Access Compliance Report

Public Rights-of-Way

(Curb Ramps)

Intersection ID: 11054	Main Street: DOWNS_AV	Cross Street: NEWELL_AV	Location: S
ADA ID: A5325CA23680	Ramp Type: Perp	Initial Pass/Fail: Fail	Overall Compliance: No
Severity Score: 33.75			
Codes/Mitigation Info/Possible Solution		Field Measurements/Component Compliance

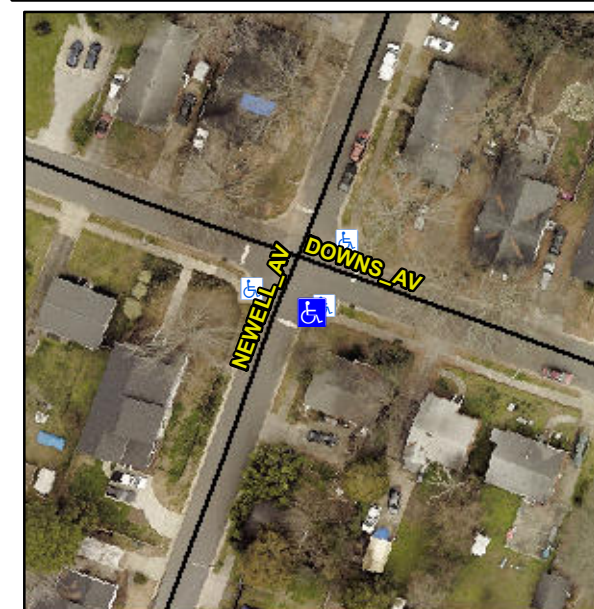
Not Found, R304.5.1, R304.5.3

Compliance	Description	Data	Compliance	Description	Data
N/A	Ramp Length (in)	65.0	Yes	Ramp Slope (%)	5.5
No	Ramp Width (in)	47.5	No	Ramp XSlope (%)	7.6
N/A	Flare Type LT	N/A	N/A	Flare Type RT	N/A
N/A	Flare Slope LT (%)	N/A	N/A	Flare Slope RT (%)	N/A
N/A	Flare Traversable LT?	N/A	N/A	Flare Traversable RT?	N/A
N/A	Landing Length (in)	N/A	N/A	DWS Provided?	N/A
N/A	Landing Width (in)	N/A	N/A	DWS Contrast?	N/A
N/A	Landing Slope (%)	N/A	N/A	DWS Length (in)	N/A
N/A	Landing X Slope (%)	N/A	N/A	DWS Full Width?	N/A
N/A	Landing Curb? (Y/N)	N/A	N/A	DWS Offset (in)	N/A
N/A	Shared Landing?	N/A			
N/A	Gutter Ponding?	N/A	N/A	Gutter Slope (%)	N/A
N/A	Gutter Lip Ht (in)	N/A	N/A	Gutter X Slope (%)	N/A
N/A	Painted X Walk1?	No	N/A	Painted X Walk2?	N/A
	X Walk 1 Direction	To NW		X Walk 2 Direction	N/A
N/A	X Walk 1 Width (in)	N/A	N/A	X Walk 2 Width (in)	N/A
	X Walk 1 Slope (%)	3.3		X Walk 2 Slope (%)	N/A
	X Walk 1 X Slope (%)	3.9		X Walk 2 X Slope (%)	N/A

Remove & Replace Entire Ramp.
